WORKSHOP AGENDA

Planning Commission

September 16, 2025 @ 5:30 PM

SHEET NO. C6.01

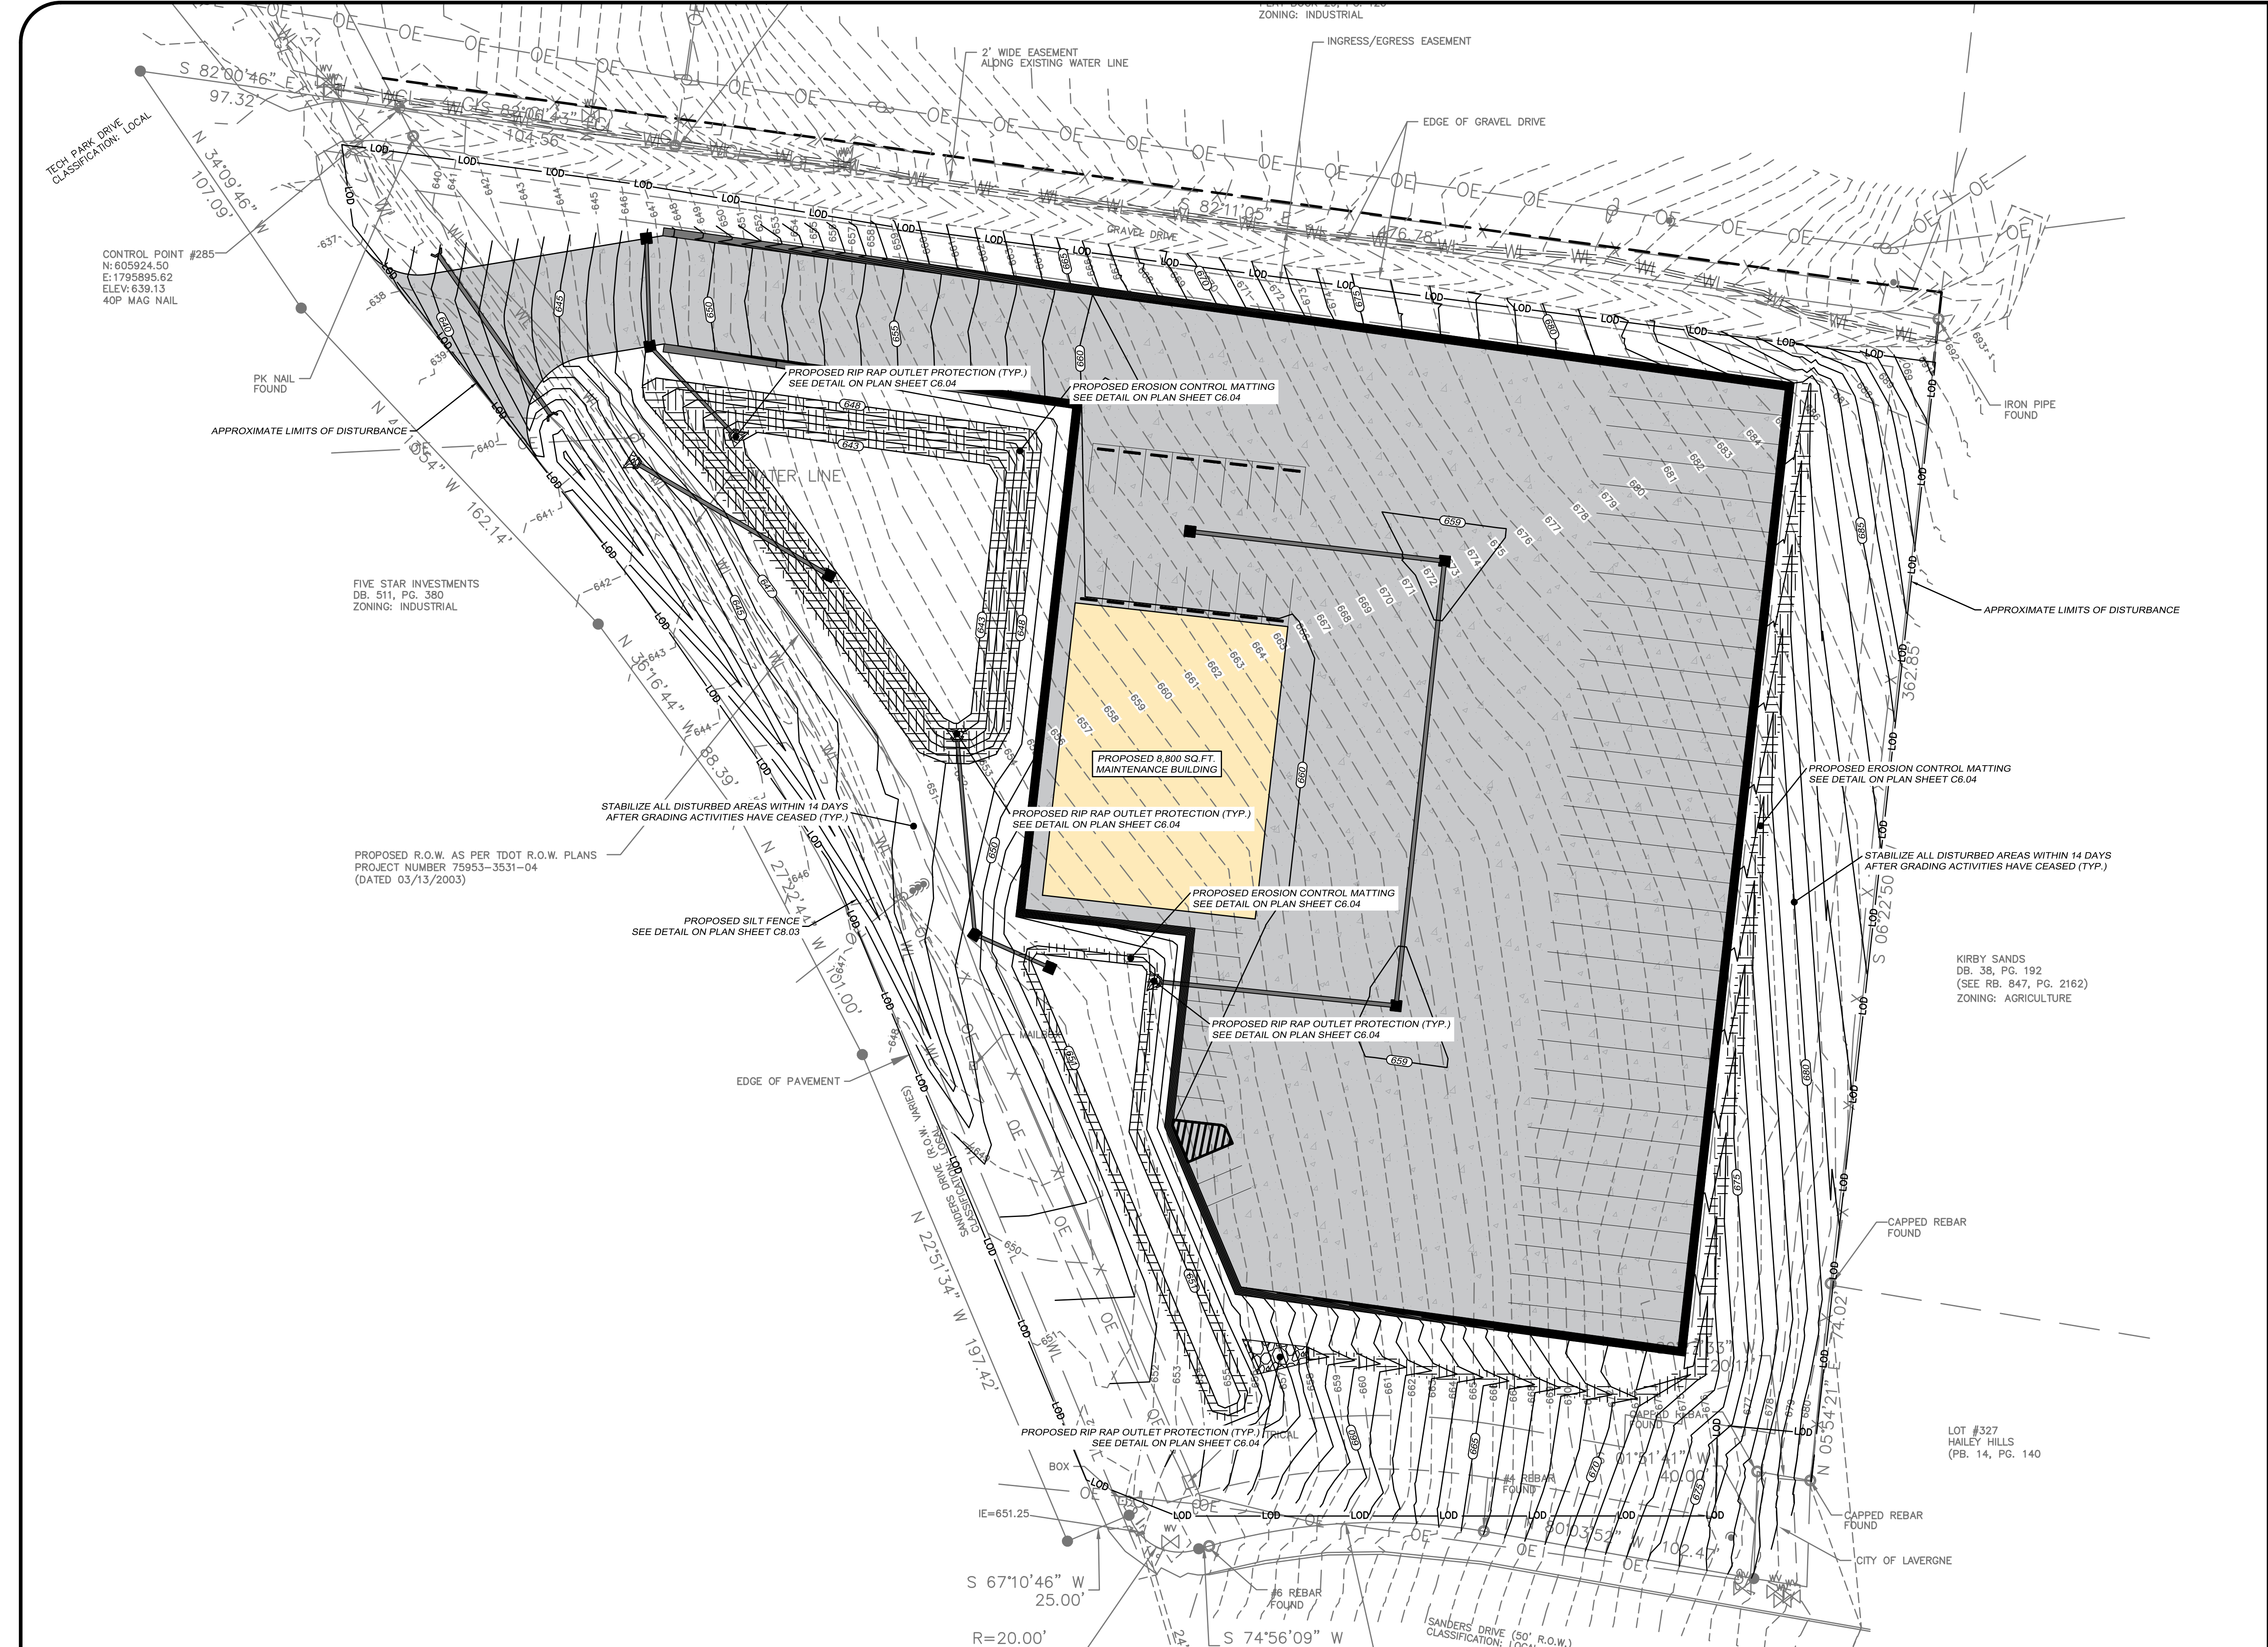
30. (Sheet C6.01, C6.02) Correct Silt Fence, Concrete Wash-out, and Construction Entrance references (the sheet reference is incorrect)
31. (Sheet C6.01) Show construction entrance graphically at 100 feet long.

34. (Sheet C6.01) Extend silt fence 100 feet in both directions
35. (Sheet C6.02) There is no Erosion Control Matting detail found on Sheet C6.04. Provide detail or change note.

39. (Sheet C6.02) This plan needs to show the grading necessary for the sediment ponds to comply with Item 38 above.
40. (Sheet C6.01) Show inlet protection at the existing culvert under the existing access drive along the north boundary.
